TOWN OF SOUTHBURY, CONNECTICUT
ADDENDUM NO. 1
REPLACEMENT OF BRIDGE NO. 130-009 OLD FIELD ROAD
OVER BULLET HILL BROOK

Bid Opening: Friday March 21, 2025
@ 10:00 AM

**TOWN OF SOUTHURY, CONNECTICUT
REPLACEMENT OF BRIDGE NO. 130-009
OLD FIELD ROAD OVER BULLET HILL BROOK**

Meeting Minutes

NO. DATE BY
1 CURB REVISED CAD

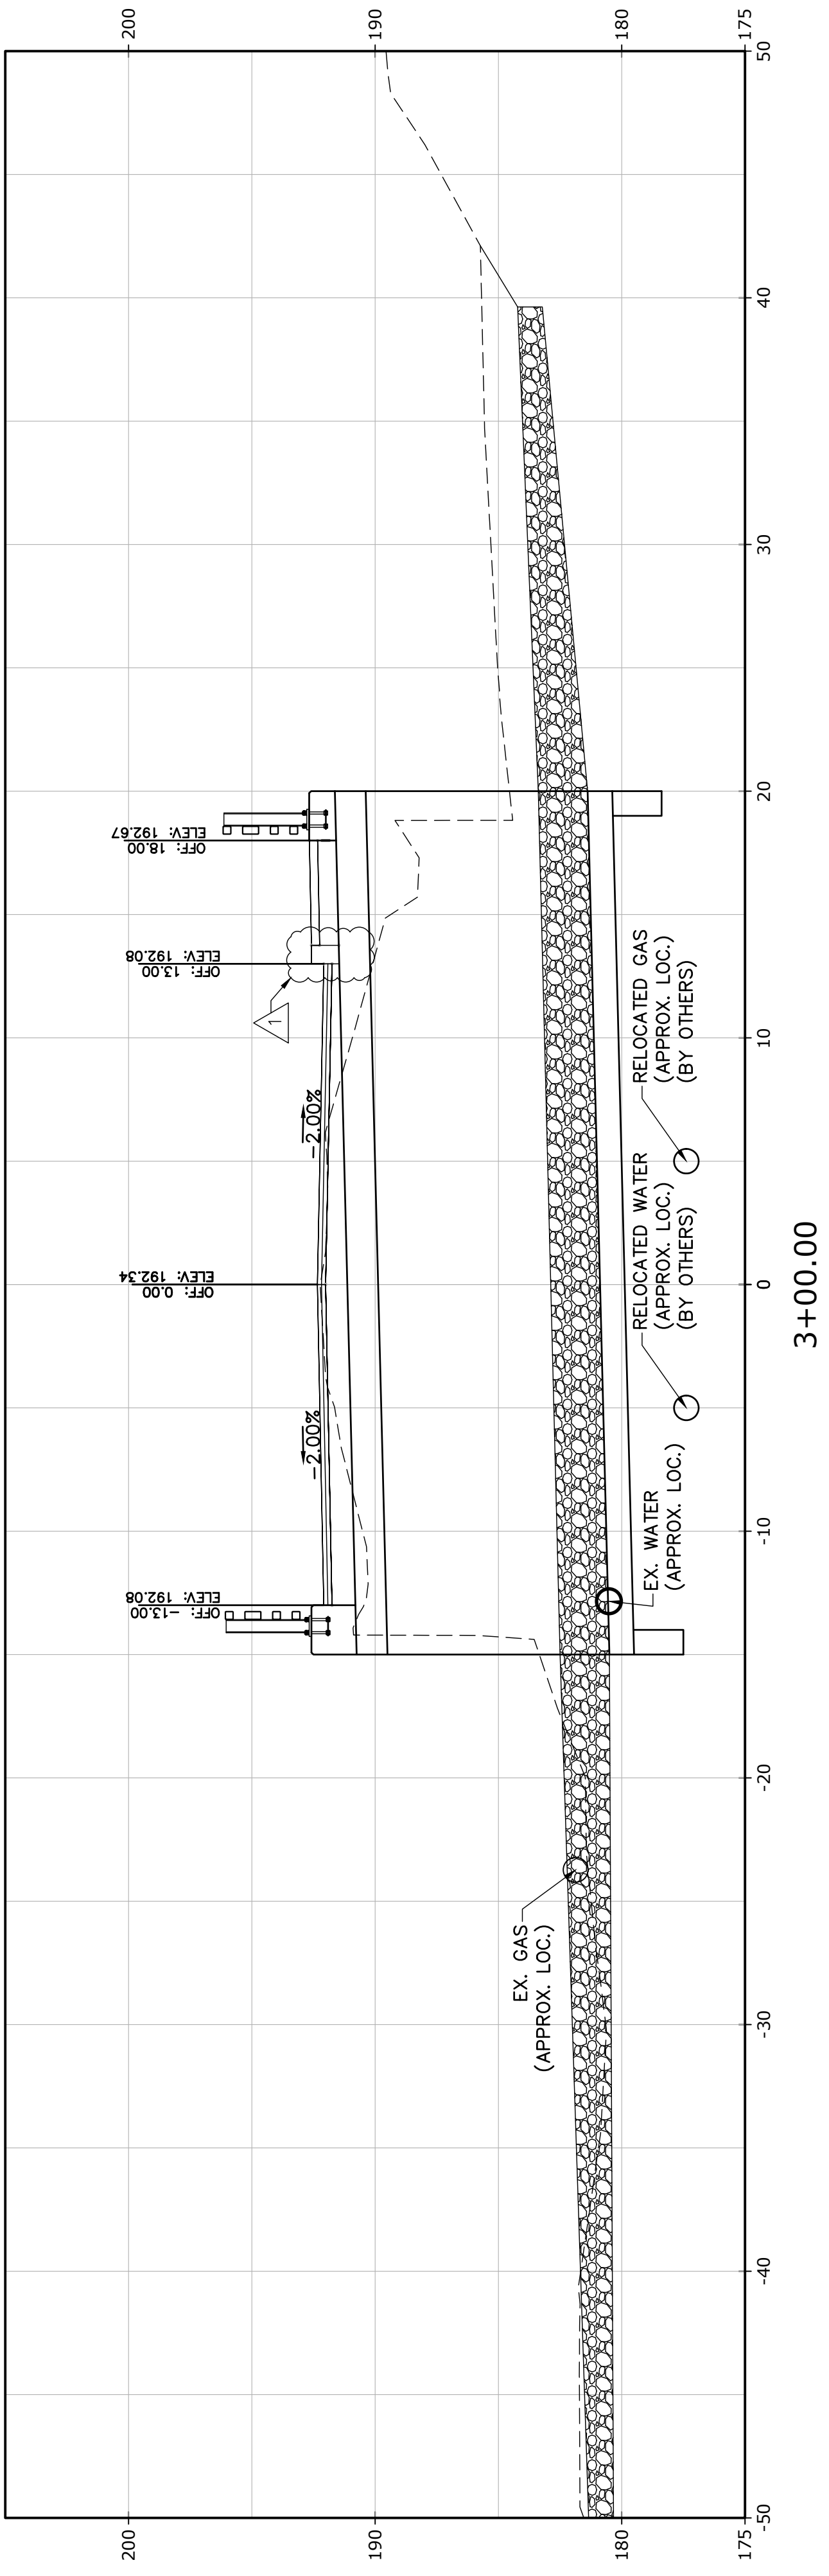
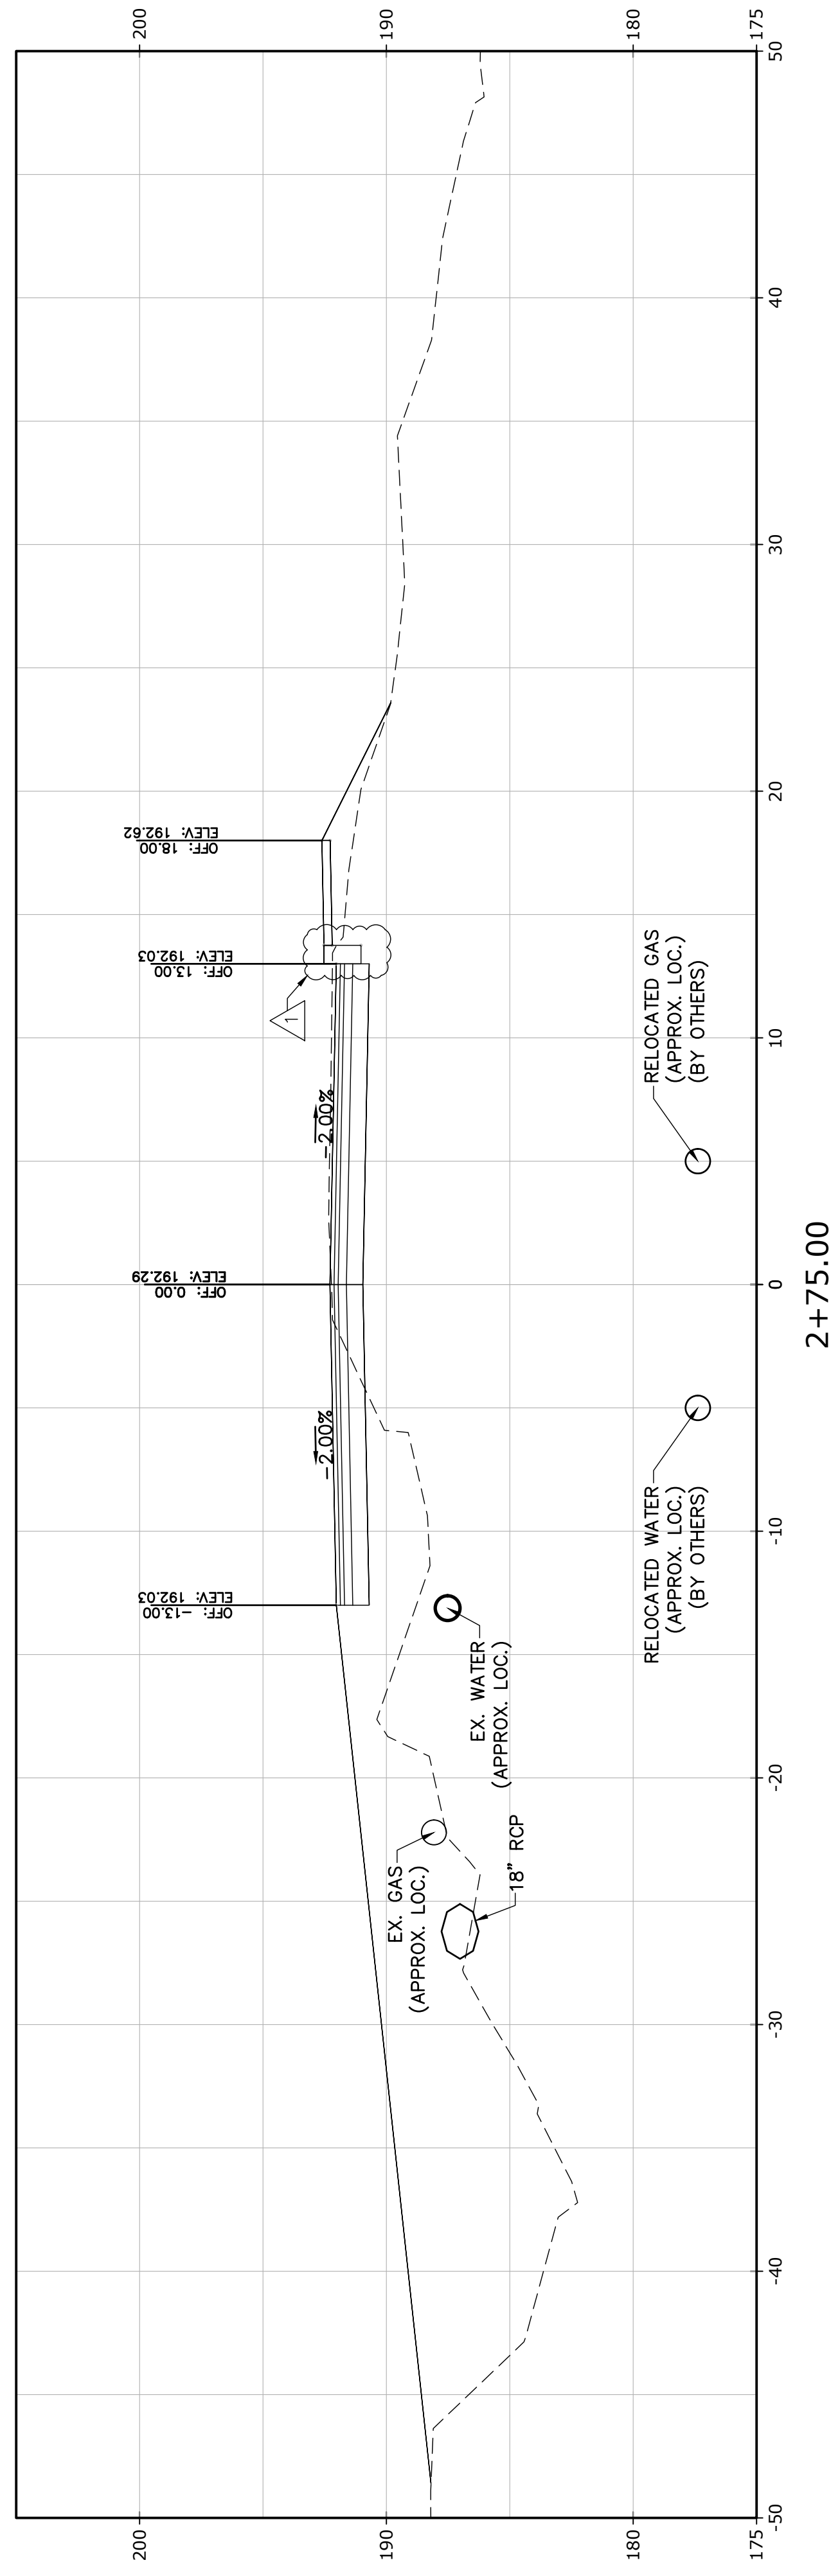
NO.	REVISION	DATE	BY
1	CURB REVISED	03/17/2025	CAD

GENERAL NOTES:

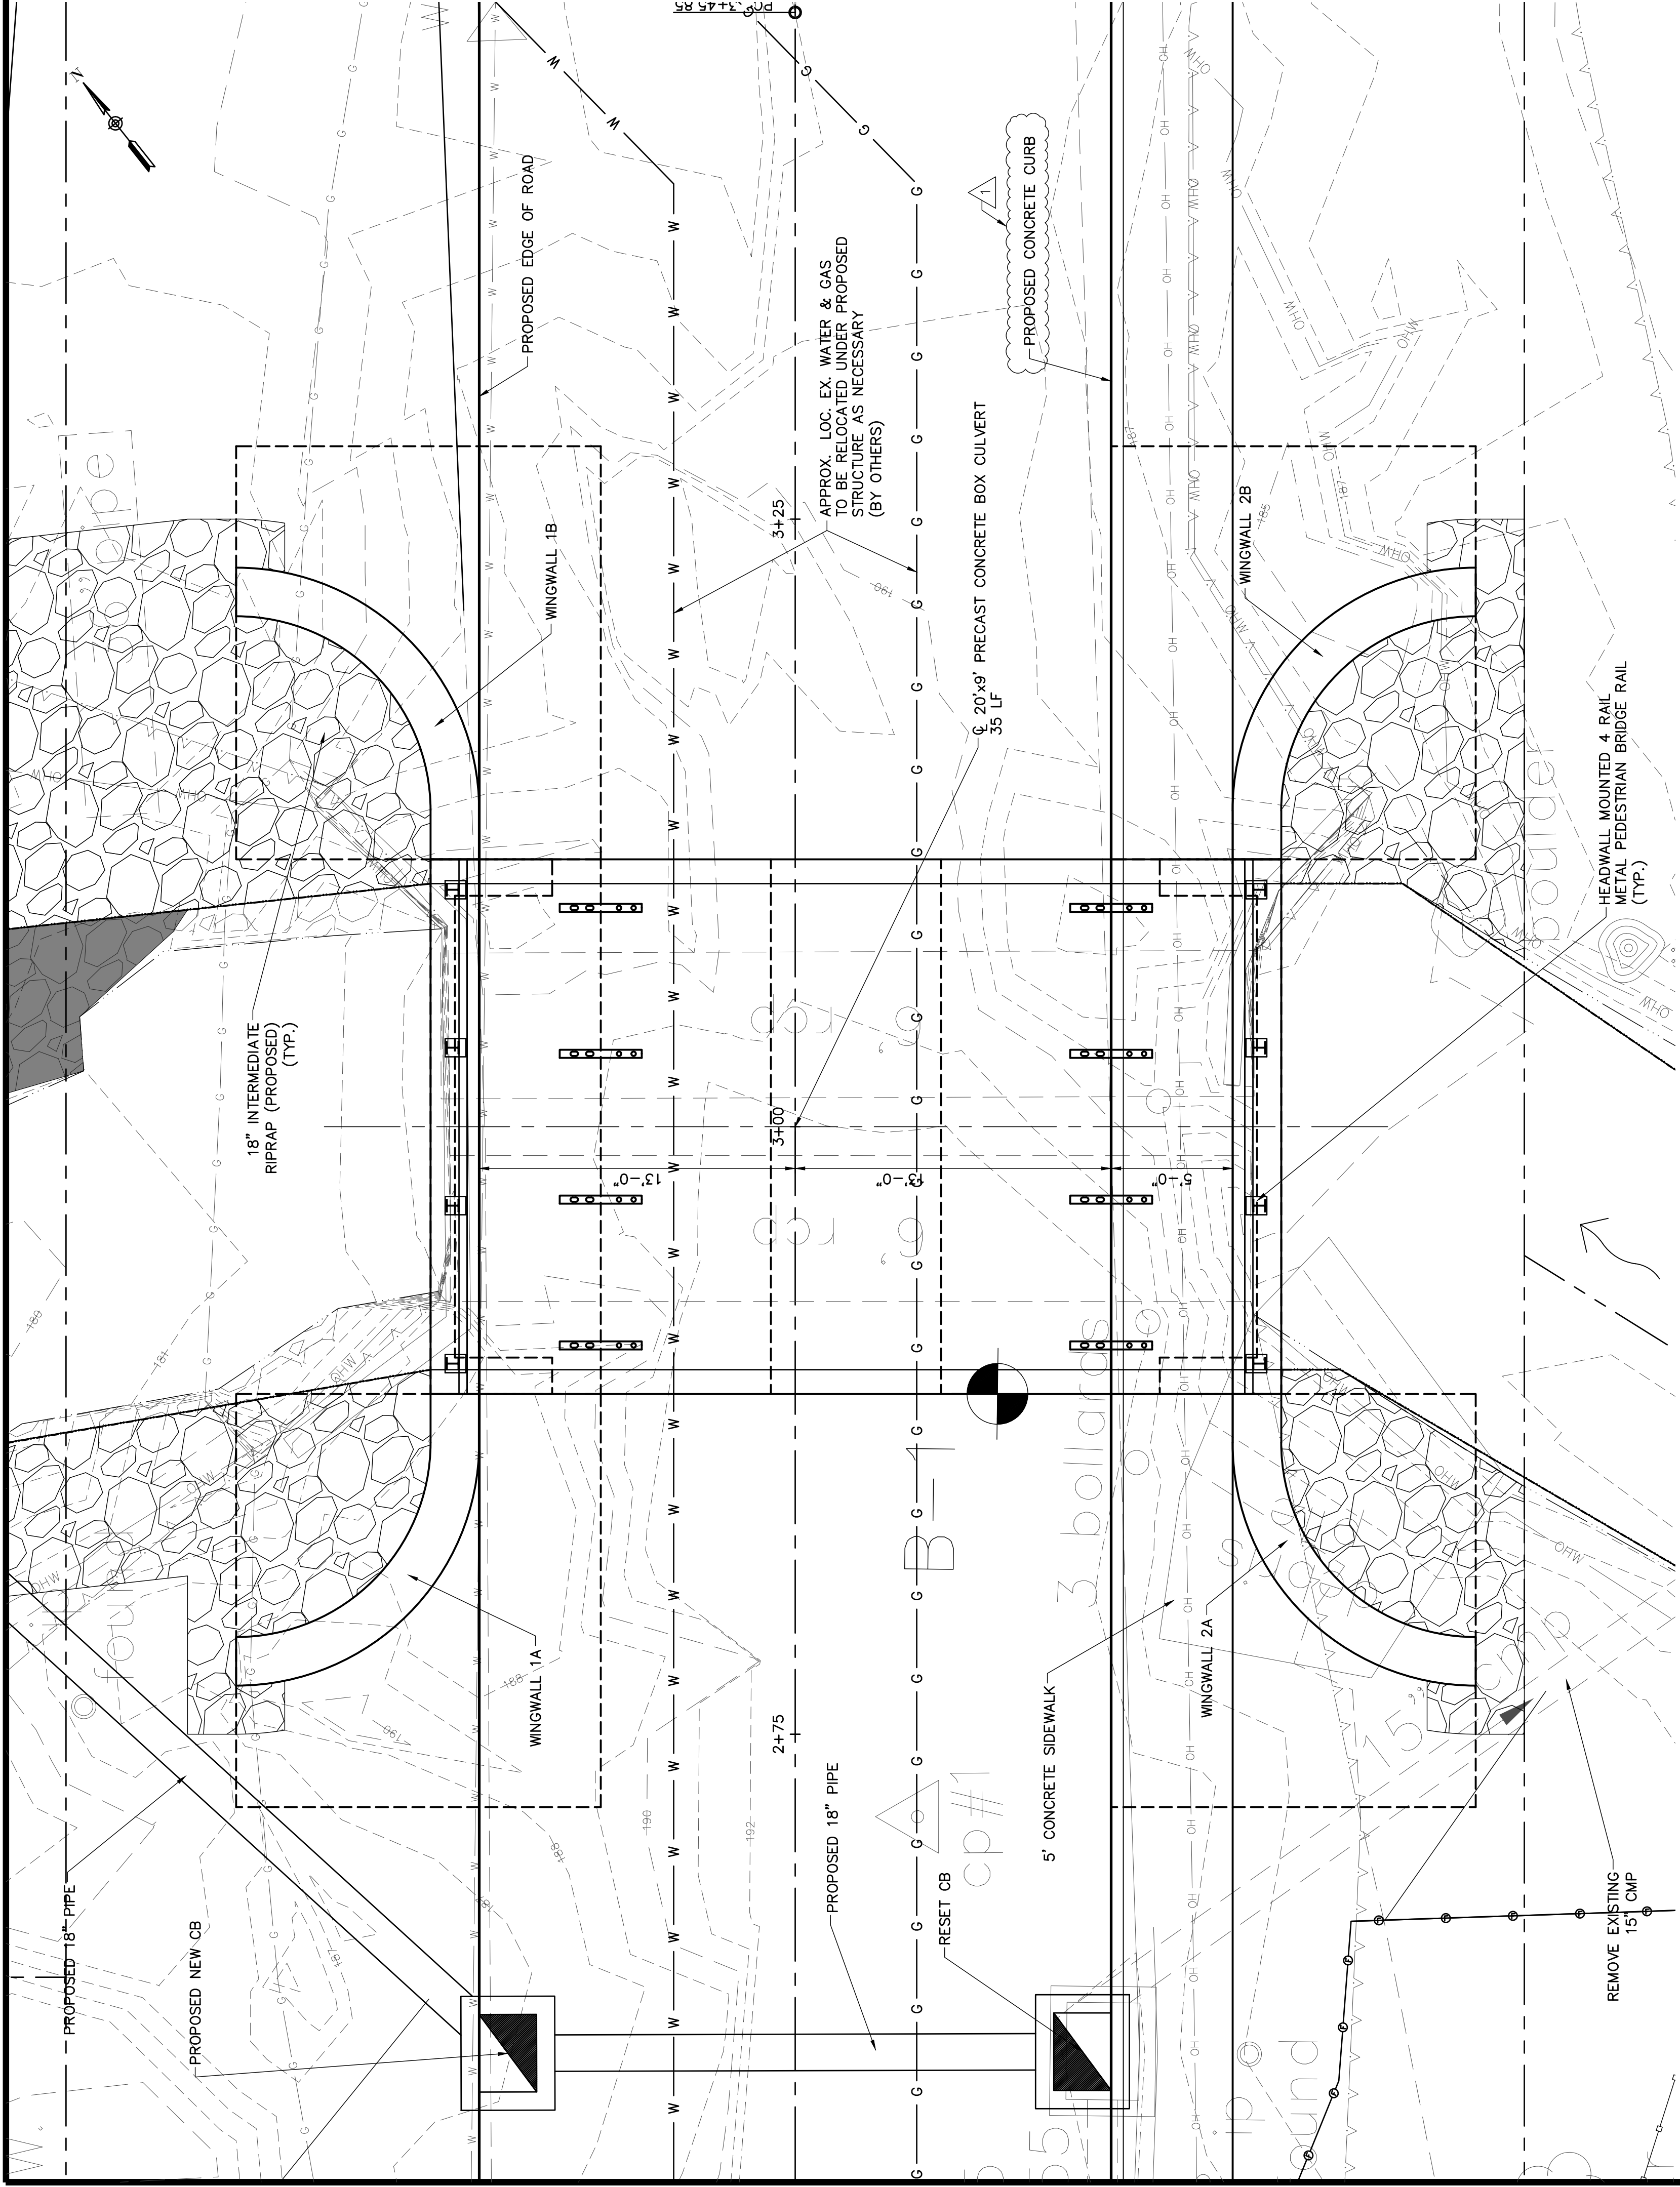
NO.	REVISION	DATE	BY
1	NOTES REVISED	03/17/2025	CAD

REPLACEMENT OF OLD FIELD ROAD CULVERT
 OVER BULLET HILL BROOK
 SOUTHURY, CONNECTICUT
 CULVERT ELEVATION AND SECTIONS

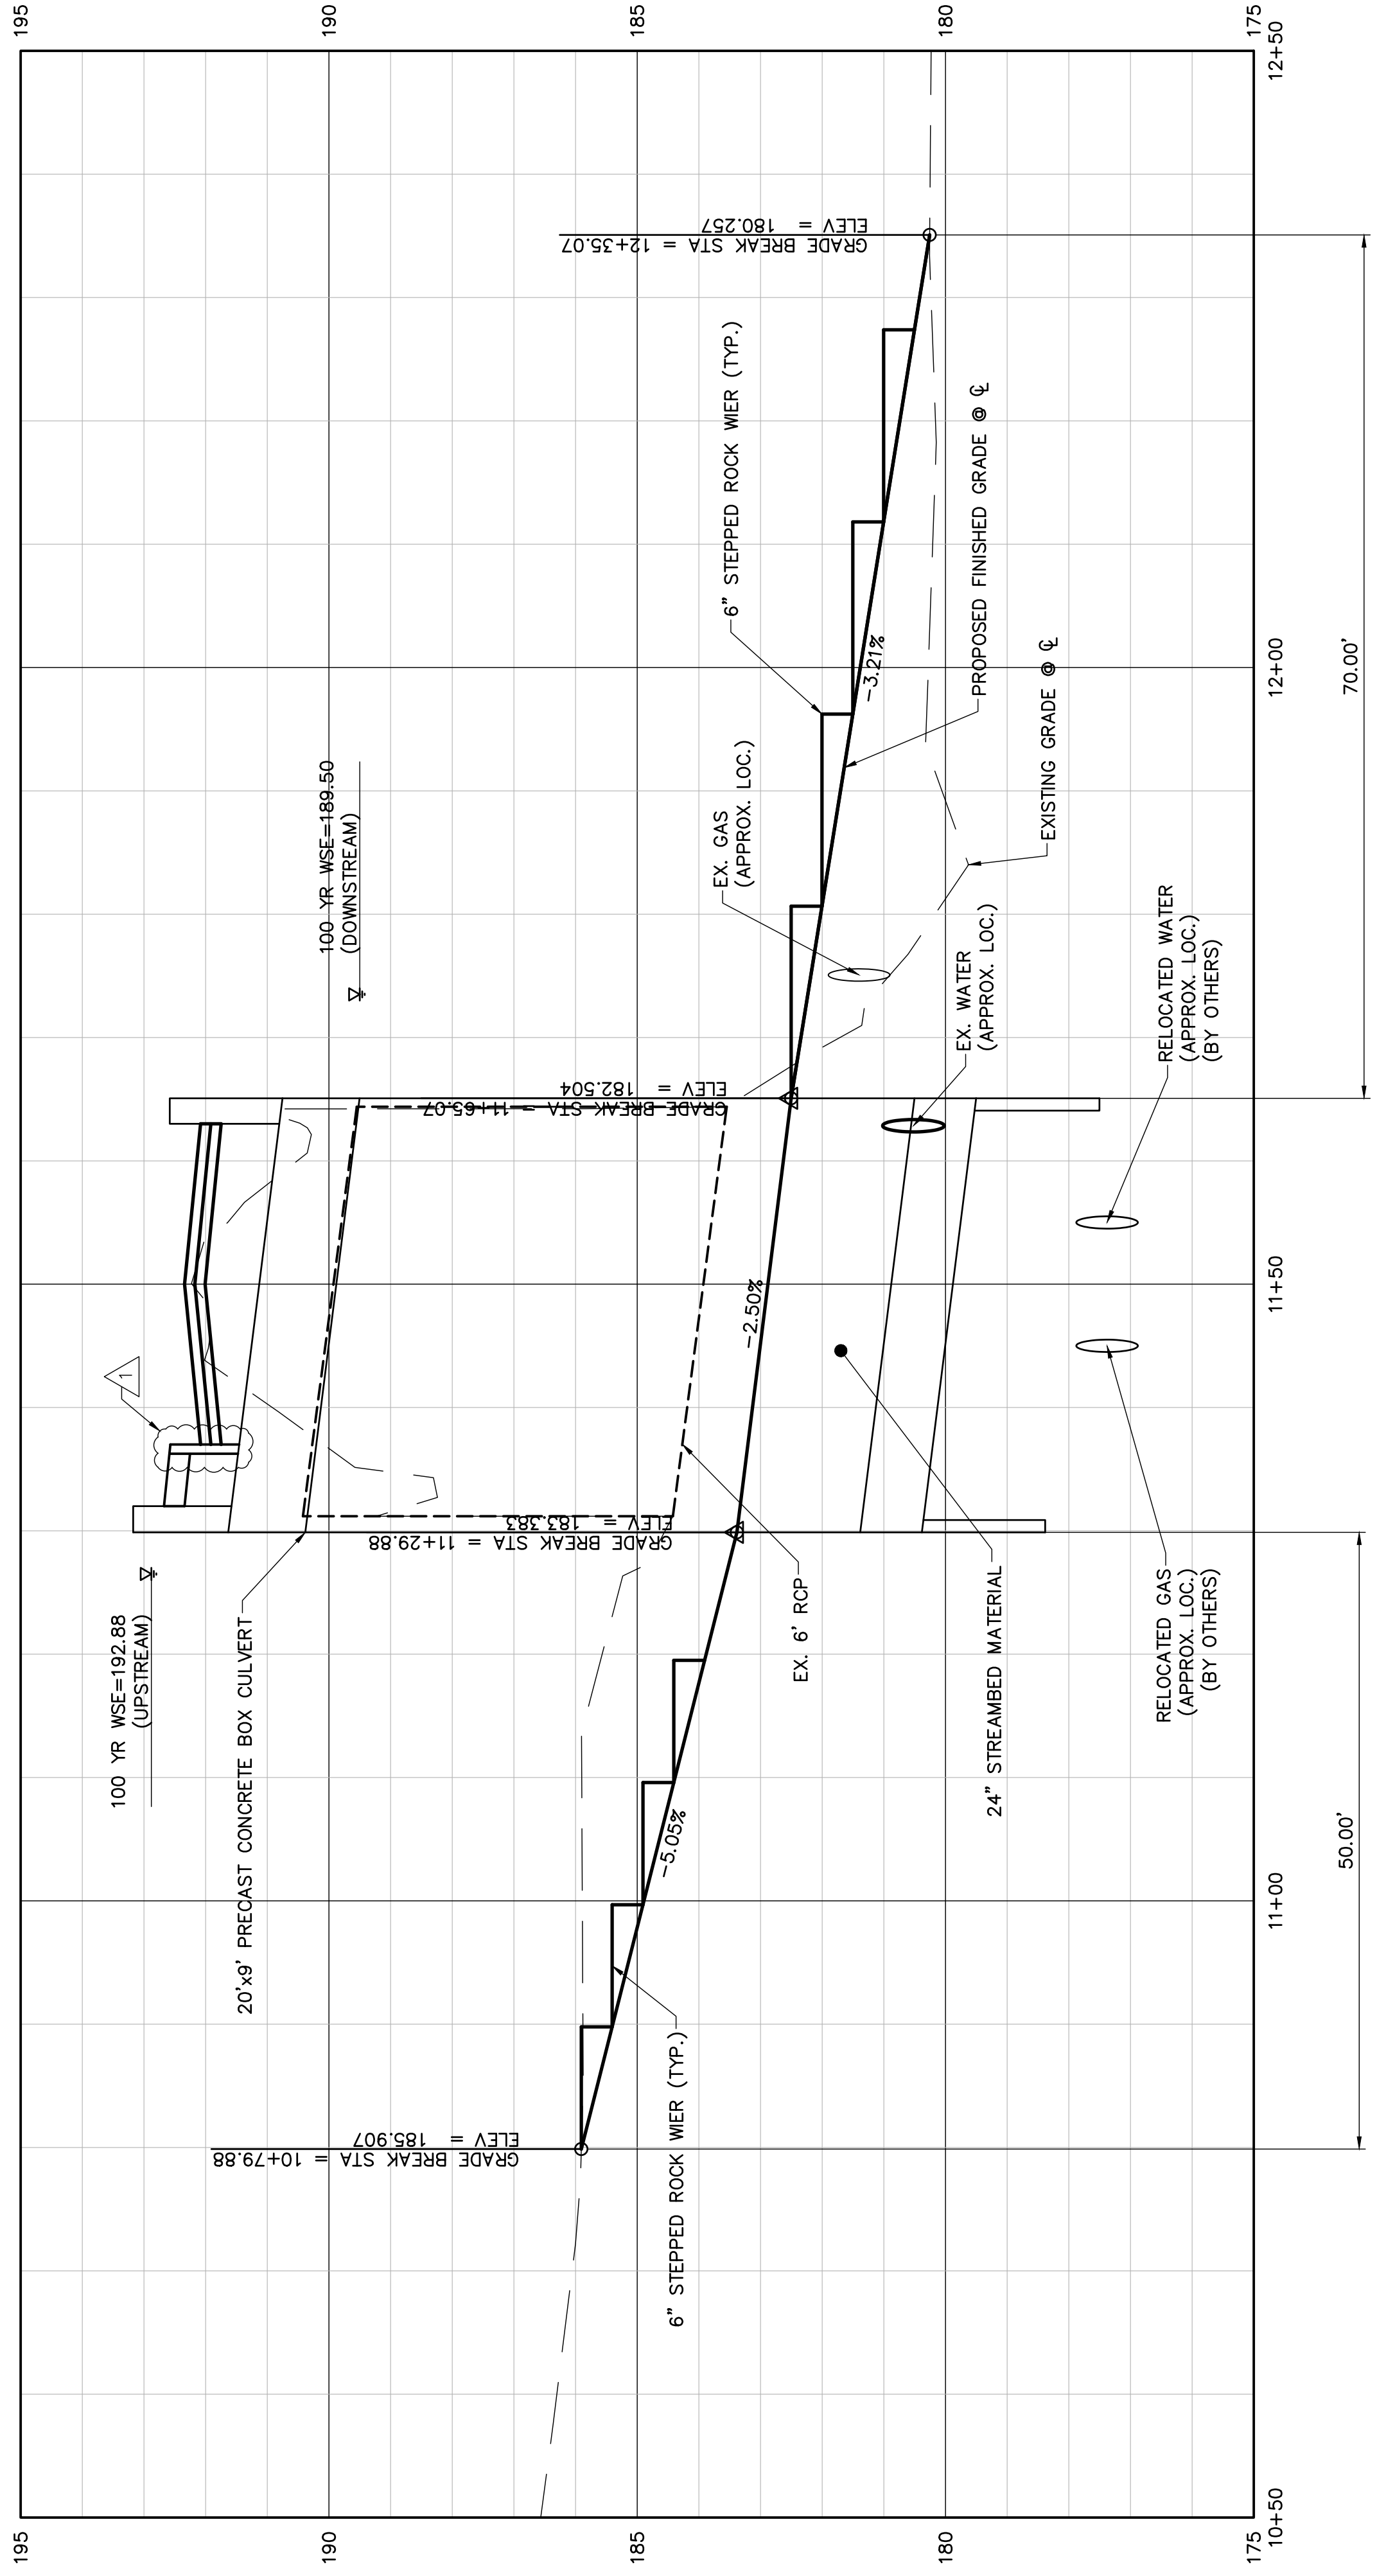
NO.	REVISION	DATE	BY
1	CURB REVISED	03/17/2025	CAD
